# Work Order ID 111381

Item Name: Fwd Crosstube - High

DRAWING NO. D212-664-141	TITLE XTUBE ASSY (205/212/412 HI FWD)	REV. D	DART AEROSPACE LTD ENGINEERING ORDER		D.E.O. NO. D212-664-141-D-1	SHEET NO. SHEET 1 OF 2	SCALE NTS
DRAWN	CHECKED	MP	MFG. APPR.	ER	APPROVED	MP	DE APPR.
DATE 11.04.07	DATE 11.04.11		DATE 11.04.12		DATE 11/04/12		DATE 11.04.12

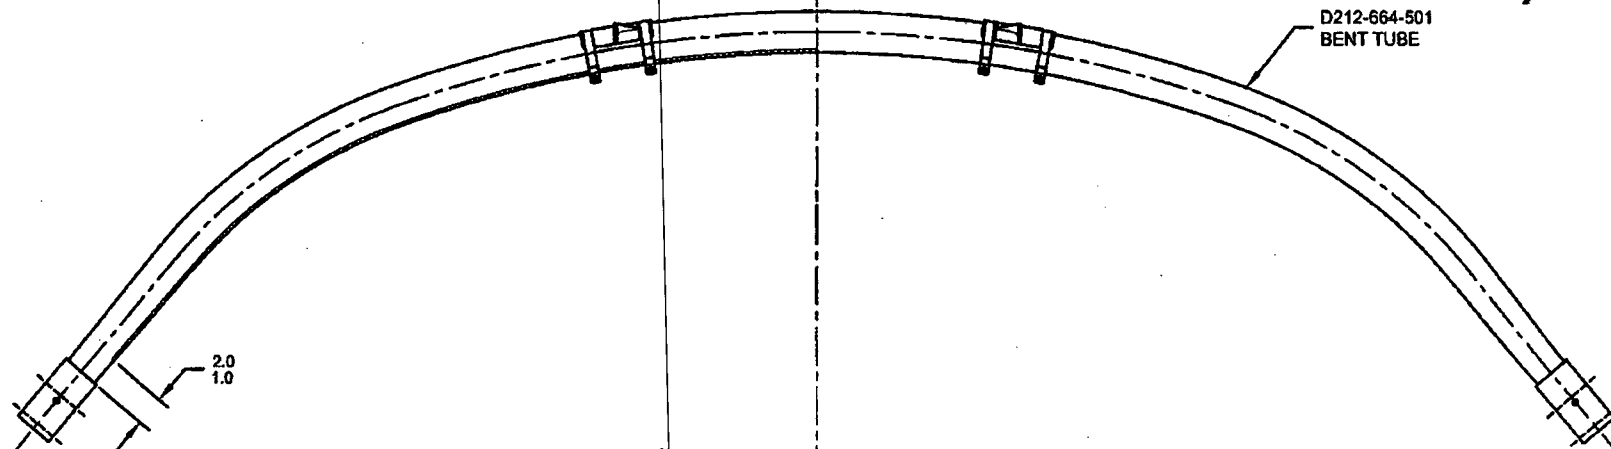
ADD AN INSPECTION WINDOW TO UNDERSIDE OF CROSSTUBE.

NOTES 2 OF SHEET 1 IS AMENDED AS FOLLOWS:

- 2) FINISH: CHEMICAL CONVERSION COAT PER DART QSI 005 4.1  
PRIME INSIDE AND OUTSIDE PER DART QSI 005 4.2  
MASK UNDERSIDE OF CROSSTUBE AS SHOWN (HATCHED AREA) AND  
PAINT OUTSIDE PER DART QSI 005 4.2  
REMOVE MASKING AND APPLY CLEAR COAT

**D212-664-141/-141B  
ASSEMBLY DETAIL**

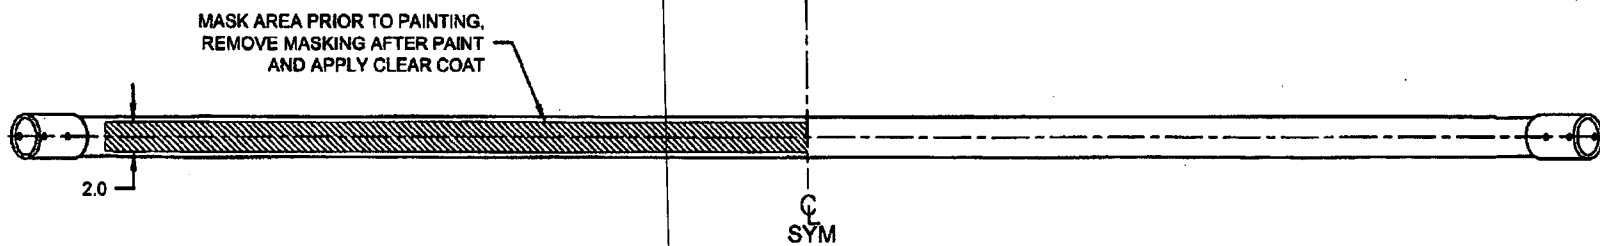
REPLACE MAGNOBOND WITH PROSEAL.

NOTE 12 & 15, SHEET 1 IS AMENDED AS FOLLOWS:

- 12) TO INSTALL D2893-1 SUPPORT: ABRASE MATING SURFACE OF SUPPORT AND CROSSTUBE WITH 180-GRIT SANDPAPER AND REMOVE RESIDUE WITH MEK (OR EQUIVALENT). APPLY A 0.04" TO 0.07" THICK LAYER OF PROSEAL 890 CLASS B-2 (OR AMS-S-8802 CLASS B-2) SEALANT TO MATING SURFACE OF SUPPORT.
- 15) TORQUE CLAMPS 80 TO 100 IN-LB. ENSURE AT LEAST 1.5 THREADS SHOWING IN SAFETY AND THAT NUT HAS NOT BOTTOMED-OUT AFTER TORQUING. **PRIOR TO PACKAGING, RE-CHECK TORQUE ON CLAMPS AFTER PROSEAL 890 SEALANT HAS CURED FOR 72 HOURS.**
